Report prepared for Rogate Parish Council Shale Gas Working Party re. UKOG plc application
SDNP/16/04679/CM

PROPOSED HYDROCARBON EXPLORATORY BOREHOLE: MARKWELLS WOOD W. MARDEN, HANTS.
UKOG (GB)

COMMENTS ON ENVIRONMENTAL STATEMENT AND GROUNDWATER RISK ASSESSMENT BY
HYDROCK CONSULTANTS LTD ON BEHALF OF UKOG (GB).

Fig. 1

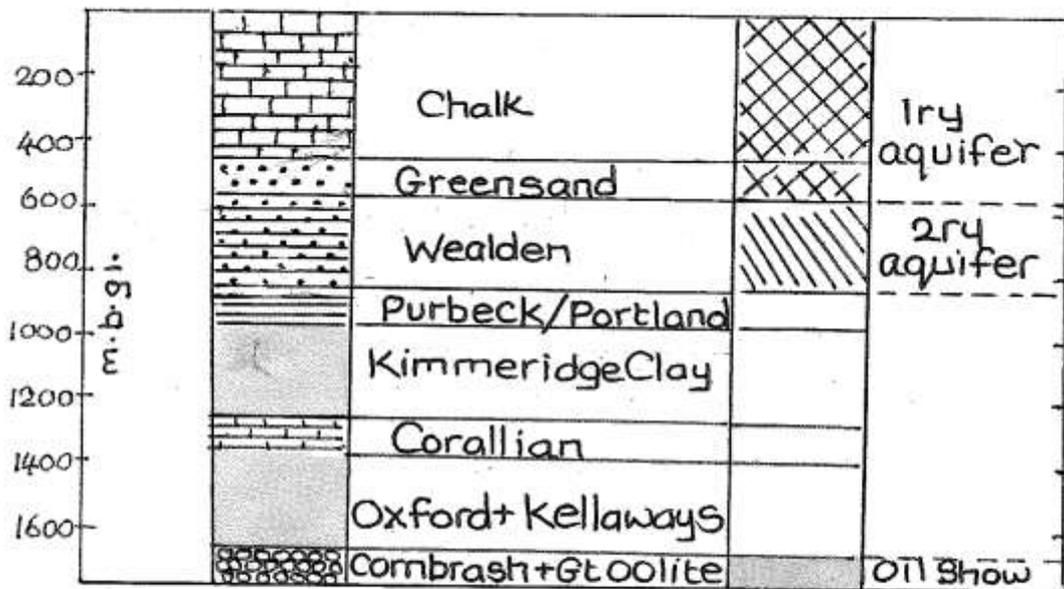
2.1. The main components of the geological succession are shown in Fig.1, based on the

lithological records for MW1 and reproduced from Tables 3.1 -3.2 of the Hydrock Groundwater Risk Assessment of Sept 2016 (www.hydrock.com) The upper 576m of the sequence includes 2 principal aquifers: the Chalk comprising 412m of fissured soft limestone, and 87m of permeable sandstones of the Upper and Lower Greensand formations.

2.2. The Chalk and Lower Greensand aquifers have been assessed by Hydrock as in hydraulic continuity, implying that the intervening Gault Clay is not impermeable and would not therefore function as a protective barrier to the migration of hydrocarbons.

Fig. 2

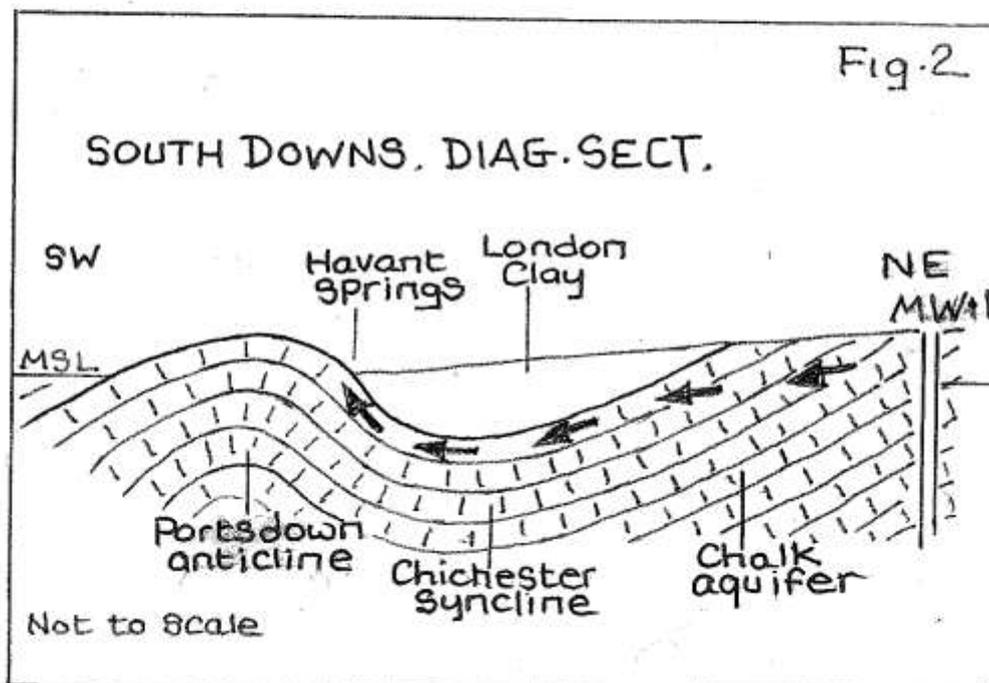
2.4. Groundwater flow is controlled by the local geological structure, characterised by the Chichester syncline and Portsdown anticline (Fig.2). Storage in the aquifer is replenished by rainfall throughout the S. Downs, and in the area NE of the Chichester Syncline, rainfall infiltration reaching the water table will be subject to a general S to SW flow path, taking it below the axis of the syncline to emerge on the Havant/(Bedhampton springline; a straight line distance of approximately 8km (Fig.3) With a mean water table level of approx. 30m AOD and the spring line close to sea level, this would give a hydraulic gradient of about 1 in 270 (or approx. 3.7m/km compared with the Applicant's figure of 1.6m/km).

2.5 It is therefore possible to discern a pathway from a hydrocarbon leakage source at the exploratory borehole site, via a network of fractures and solution fissures, to its outfall at the springs – a strategic public water supply source with a rated average discharge of 144ML/day.

Figure 2: Groundwater Flow in the Chalk

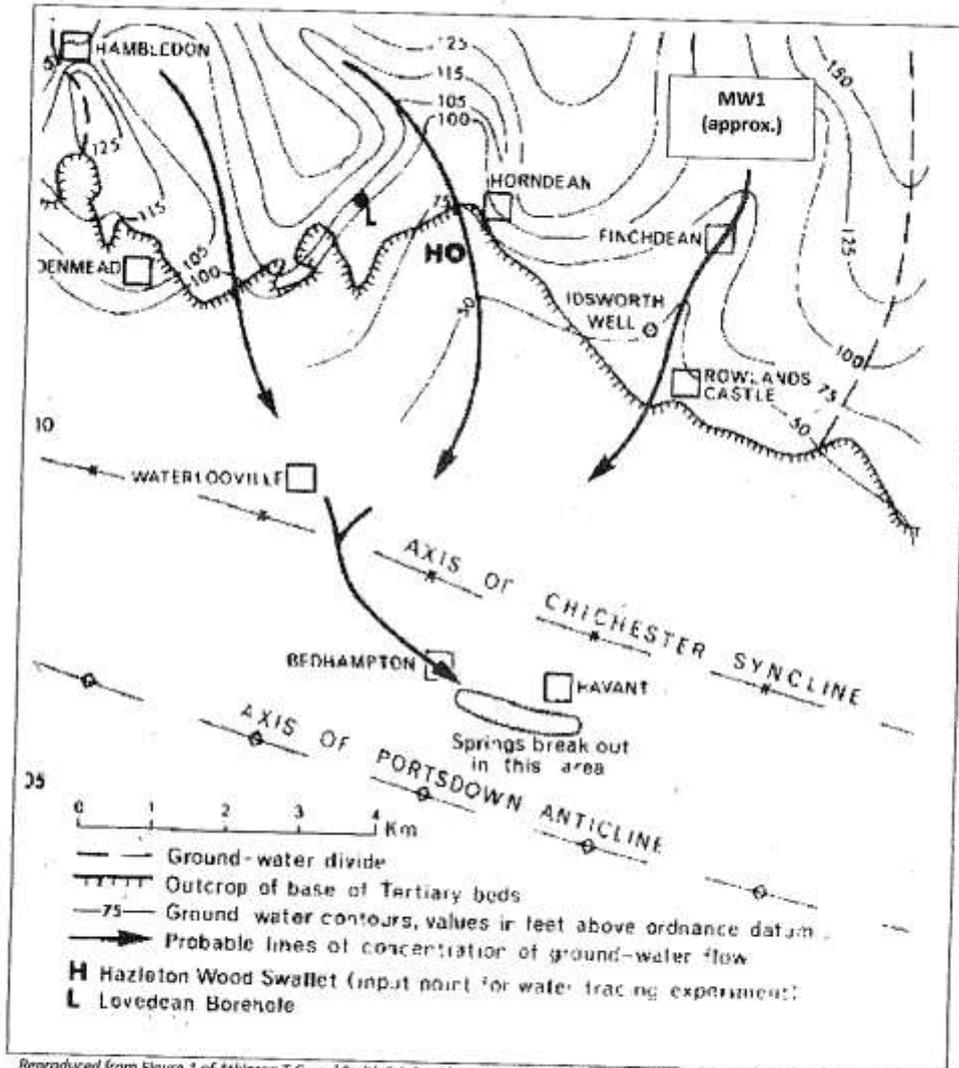
As per Figure 2, groundwater recharged from rainfall on the Chalk outcrop west of the site is considered to flow towards the Havant and Bedhampton Springs. The springs emerge where the Upper Chalk aquifer crops out at its junction with the Reading Clay near Bedhampton. The 1974 paper by Atkinson & Smith quotes earlier work by Day (1964), wherein preferential flowpaths towards the springs were identified and it may be noted that the Markwells Wood site is not on one of these flowpaths.
